CITY OF ALBUQUERQUE

Re: Drainage Control Ordinance (14-5-2-1) Violations for Erosion and Sediment Control

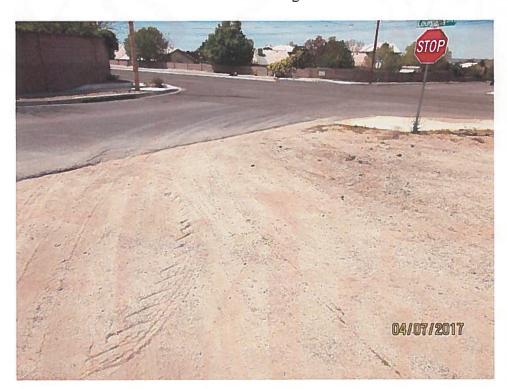
Inlet protection requires maintenance.

1. Perform maintenance on inlet protection.
